A REVIEW OF THE
PROPOSED WIPP UNDERGROUND
MINE DESIGN

A REPORT TO
D'APPOLONIA CONSULTING ENGINEERS

T. WILLIAM THOMPSON

November 16, 1979

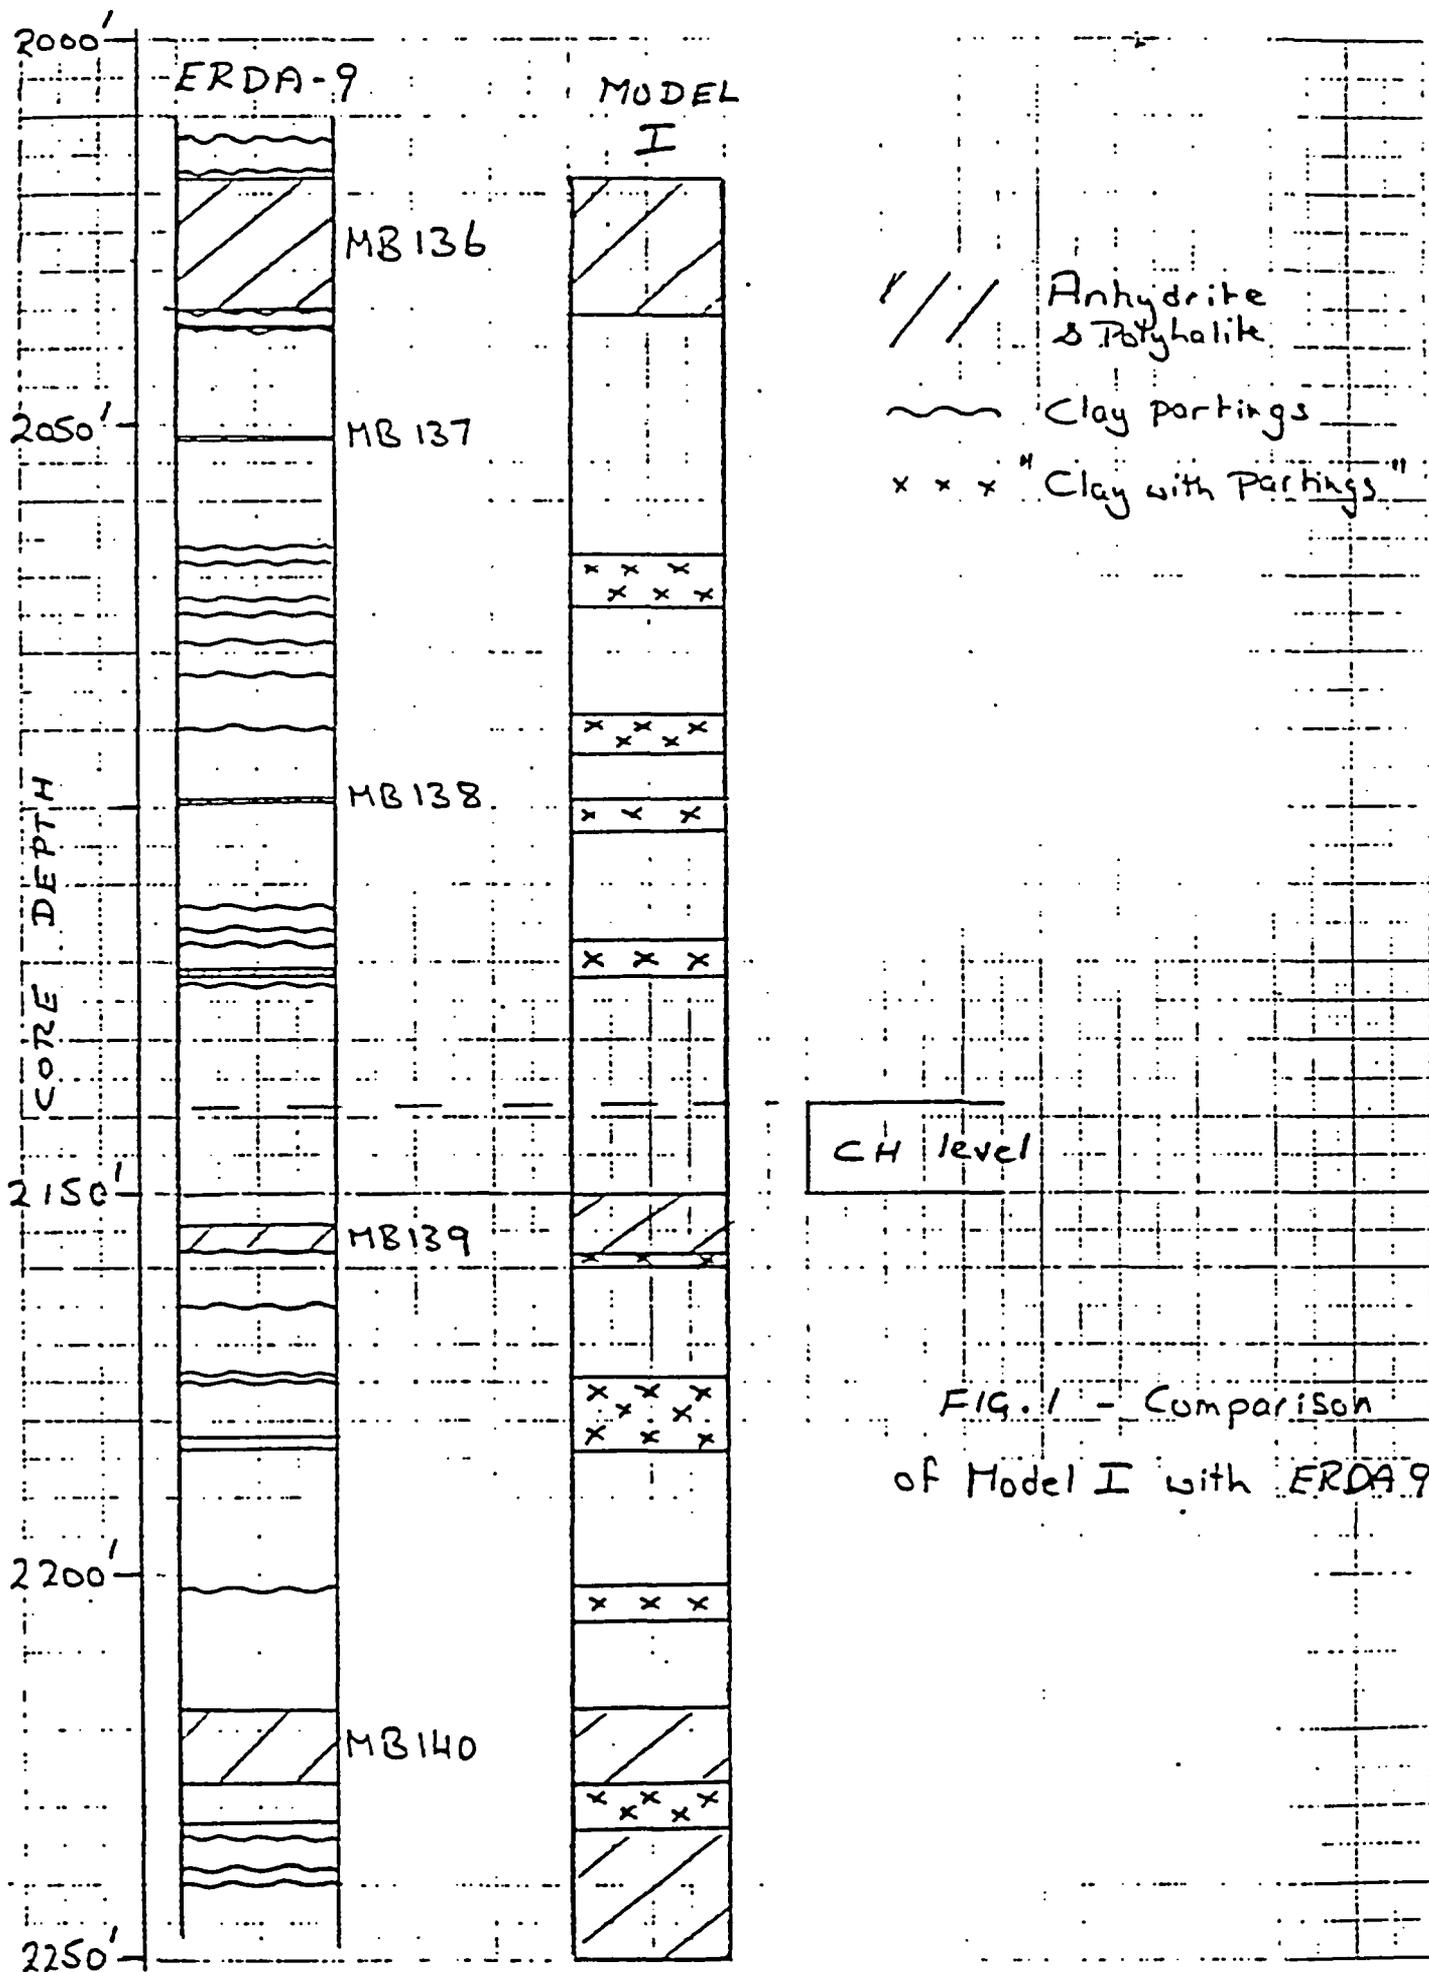
Neither of the CH level idealizations (Figs. 3.4.1, 3.4.16) show a reasonable representation of the site geology based on the ERDA-9 core logs. A detailed comparison of the ERDA 9 log and the model geology is included as Fig. 1. The most notable differences are summarized in Table 1.

Horizon	Core log (A 23)	Model (A 45)
a. MB 136	13.6 ft. thick	17.8 ft. thick
b. MB 138	0.7 ft. anhydrite with basal parting	absent
c. anhydrite	0.9 ft. at 2120.9; clay parting at base	absent
d. MB 139	3 ft. thick anhydrite; top at 2154.3, 4.3 ft. <u>below</u> CH level	8 ft. thick; top at 2150, floor of CH level
e. anhydrite	absent	2233-2249.8

Clay seams are included in the model as "clay with partings" in beds of appreciable thickness. This 'lumping' technique is invalid since the importance of the clay seams is most likely to be in their lack of tensile and shear strength and the resulting contribution to potential bed separation. The "clay with partings" beds do not correlate well with the identified clay partings in any case. The omission of the clay partings and anhydrite in the near roof and floor of the CH level are particularly serious.
